Class 2 Permit Modification Request

Update Ventilation Language

**Waste Isolation Pilot Plant
Carlsbad, New Mexico**

WIPP Permit Number - NM4890139088-TSDF

Figure 5
Location of Worker Emplacing RH-TRU Mixed Waste

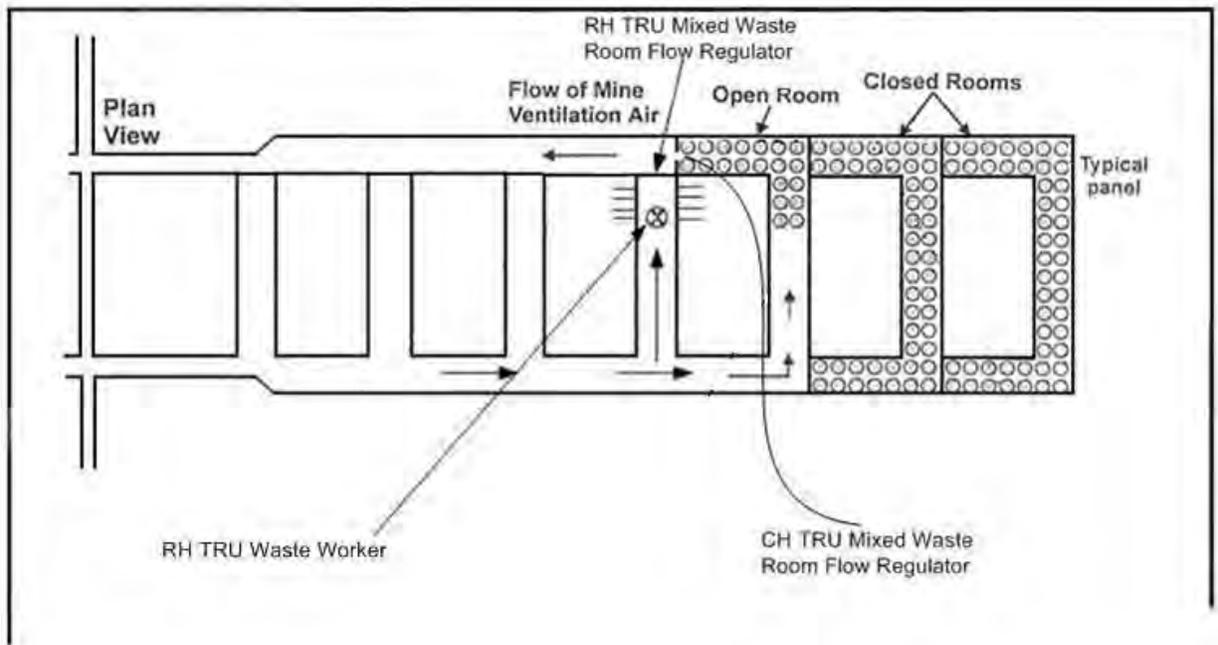
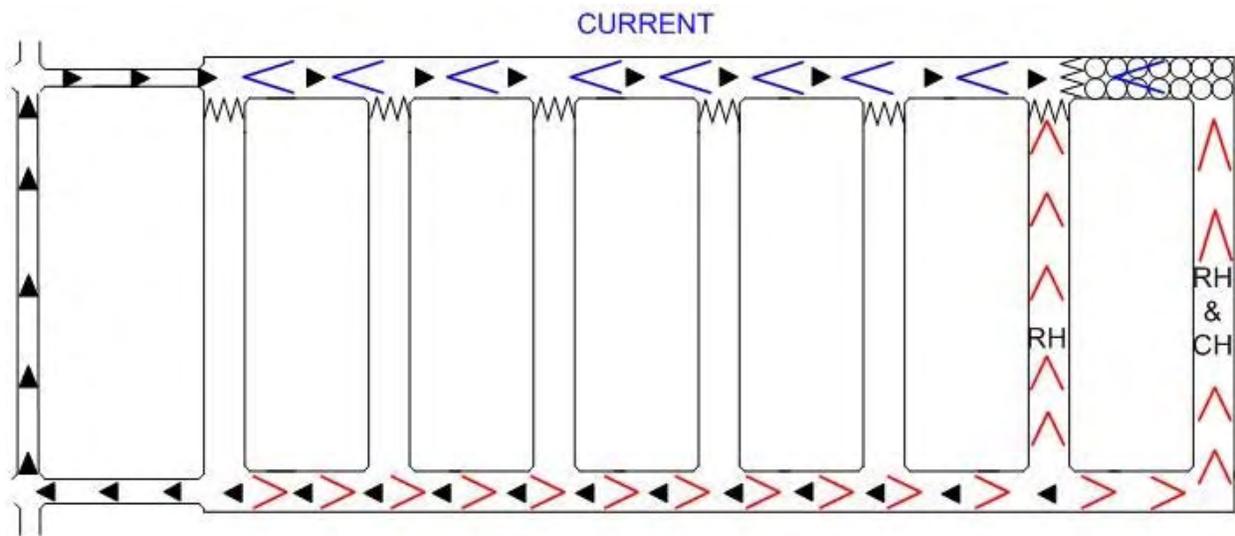
At the time the Permit was issued in 1999, RH TRU waste was prohibited and RH TRU waste emplacements were not included in the NMED's ventilation analysis. Rooms that are being filled with RH TRU waste represent one additional scenario as shown in Figure 5. As can be seen in Figure 5, the worker is unaffected by normal operations or a roof fall in the adjacent CH TRU mixed waste room and by any roof fall scenario in the adjacent filled room by virtue of the fact that the ventilation flow through the active CH TRU mixed waste room bypasses the active RH TRU mixed waste room. In other words, because RH TRU mixed waste rooms are upstream from CH TRU mixed waste rooms, the RH TRU mixed waste worker in an RH TRU

mixed waste room is never in the CH TRU mixed waste room ventilation stream, and therefore would not be subject to the consequences of the roof-fall scenario.

Figure 6
Current and Proposed Routes

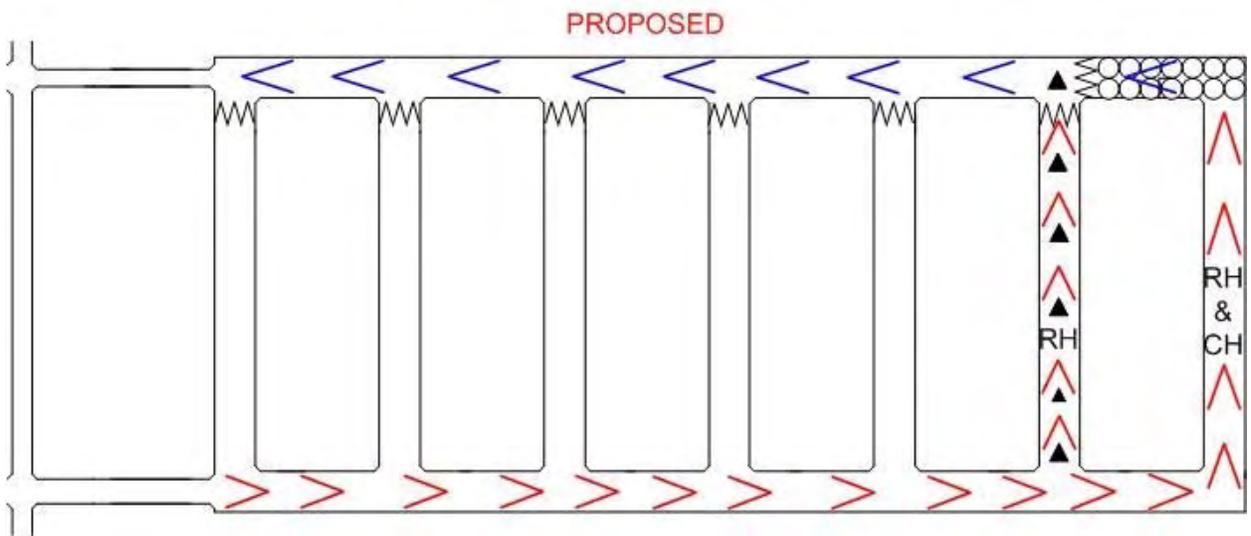
Figure 6 shows the current and proposed worker pathways to adjust the ventilation regulators. Clearly, the pathway allowed by this proposed modification is significantly shorter and thereby reduces the time that a worker must be downstream of the emplaced waste.
